CHANGES SUBMISSION. SET-2

Pool Terrace Changes. DRC Meeting Package Submission - **01-13-2015**

**Proposed Student Housing at Tyndall Avenue**

The Hub at Tucson II

Proposed West Elevation

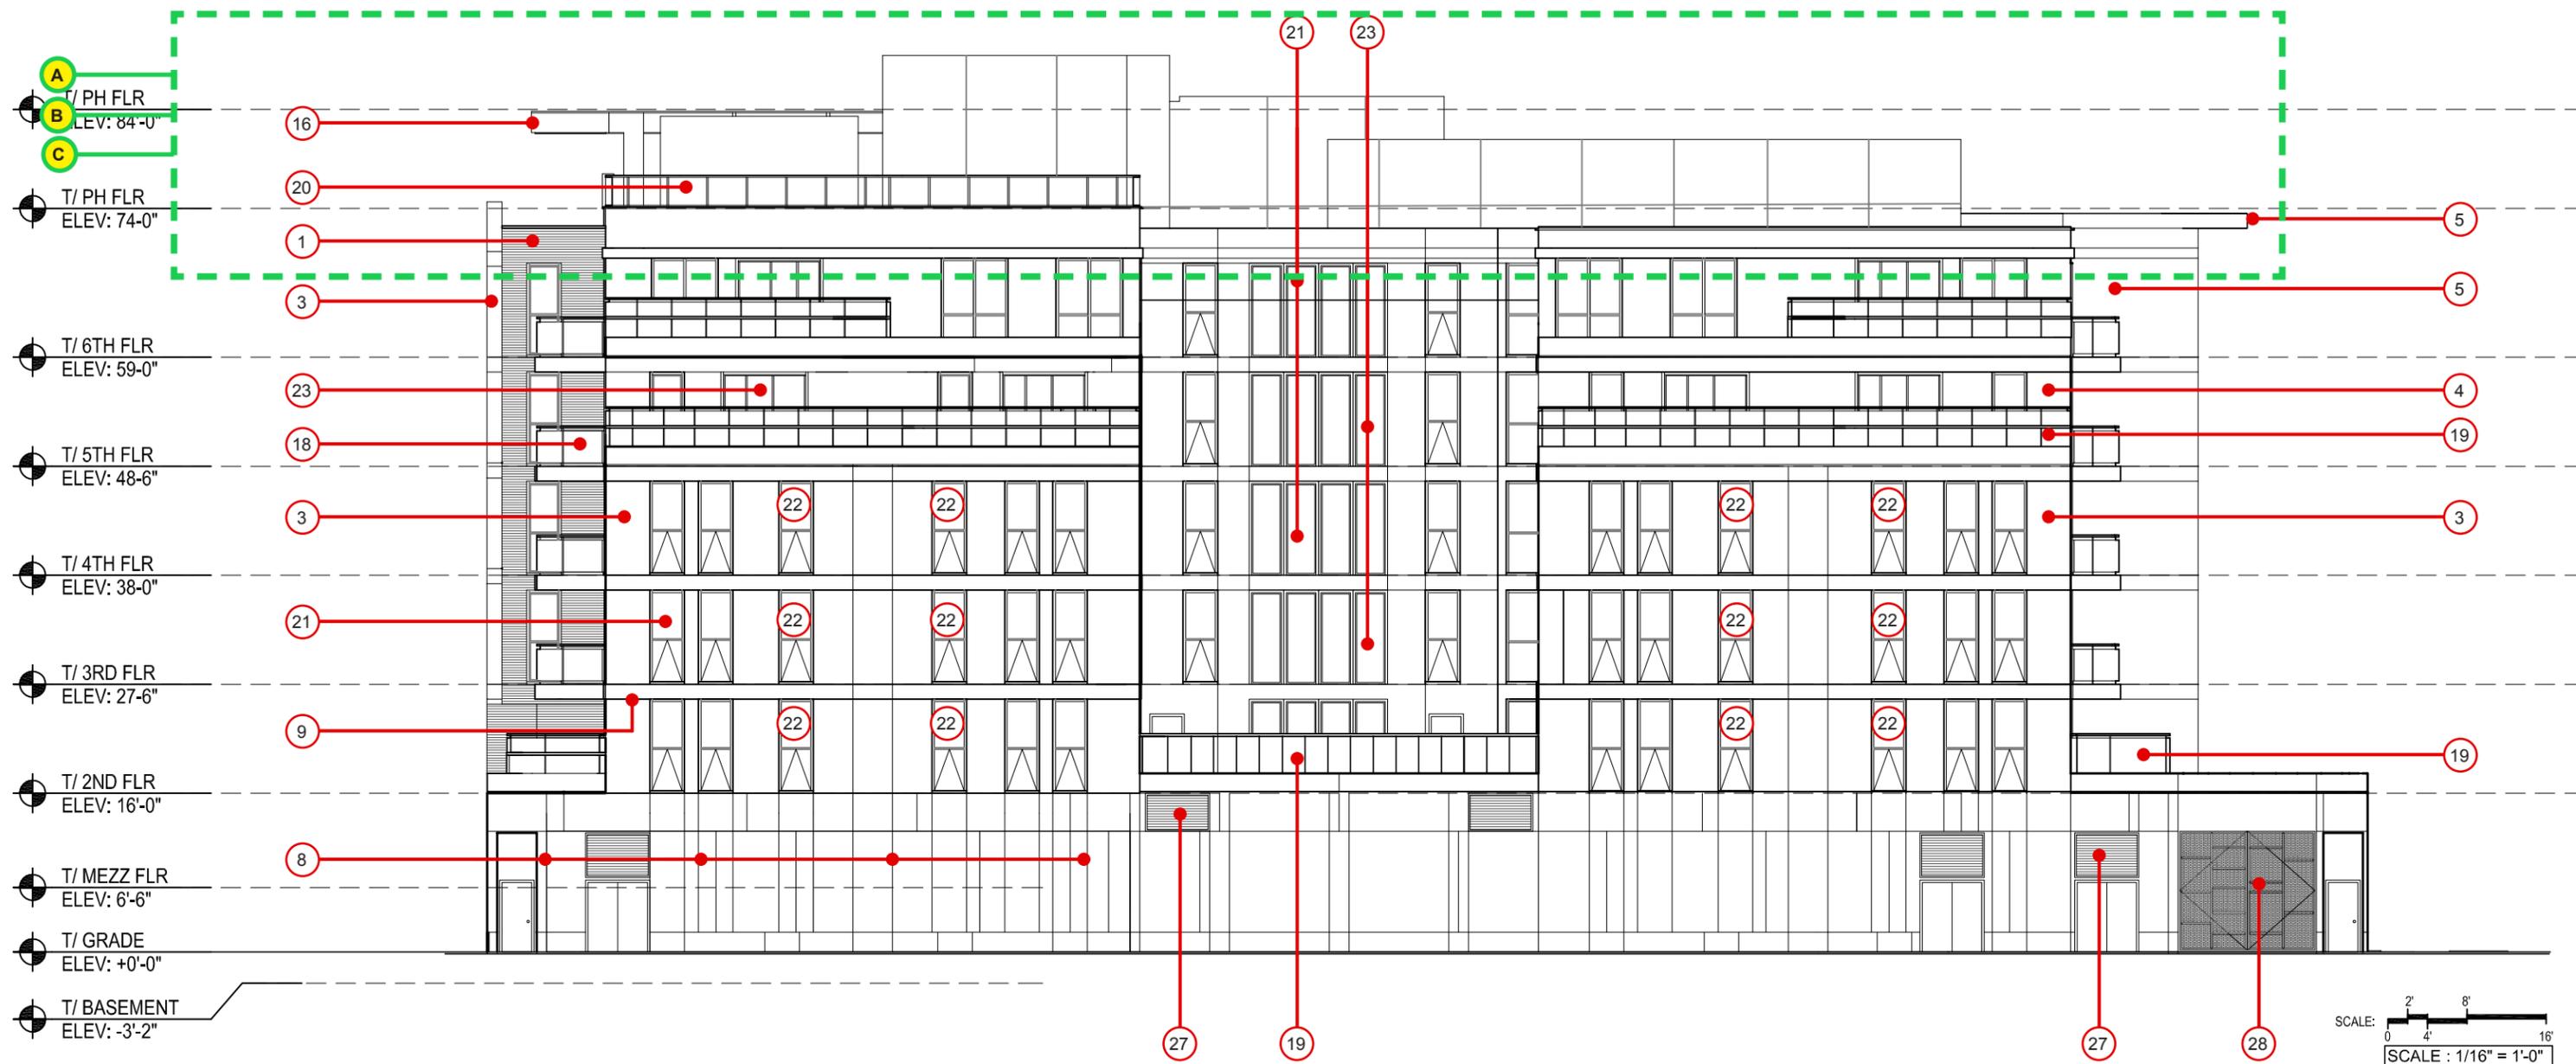
- **A** - Water meter enclosure and transformer room relocated from west alley to the Tyndall street facade. Garage door size reduced.
- **B** - Mechanical screen altered. Secondary screen removed and parapet height increase to 5' to act as screen, pool equipment room removed, elevator shaft footprint reduced and the elevator top of parapet height increased from 86' to 90' to allow for the mechanical lift overrun. 6th floor ceiling height increased by 1' with the south "I" eyebrow lifting by approx 1'10".
- **F** - Rooftop terrace area reduced, pool and hot tub relocated to the courtyard. Rooftop terrace screen material changed from glass infill to metal panel

infill. Extent of mechanical screen increased to location on the north wing. Landscaping altered to suit new layout.

- **G** - Revised gas meter recess location.
- **H** - Loading dock recess removed, egress door added and stucco color pattern altered to suit.
- **I** - Pool and hot tub relocated to courtyard. Screen wall height increase from 6' to 8' and landscaping altered to provide an acoustic barrier to the alleyway.
- **L** - All balconies reduced from 6' to 5' deep, excluding balconies on Tyndall

street.

- **N** - Windows moved away from adjacent balconies.
- **R** - Vision windows added to dark band and spandrel glass windows changed to vision glass. Changes due to unit layout alterations.

- **A** - Original height of 6th floor ceiling level reinstated.
- **B** - Mechanical screen altered. Secondary screen removed and parapet height increase to 6' to act as screen, pool equipment room removed, elevator shaft footprint reduced and the elevator top of parapet height increased from 86' to 90' 8" to allow for the mechanical lift overrun.
- **C** - Rooftop Pool terrace area reduced, Rooftop terrace screen material changed from glass infill to metal panel infill. Extent of mechanical screen increased to location on the north wing. Landscaping altered to suit new layout.
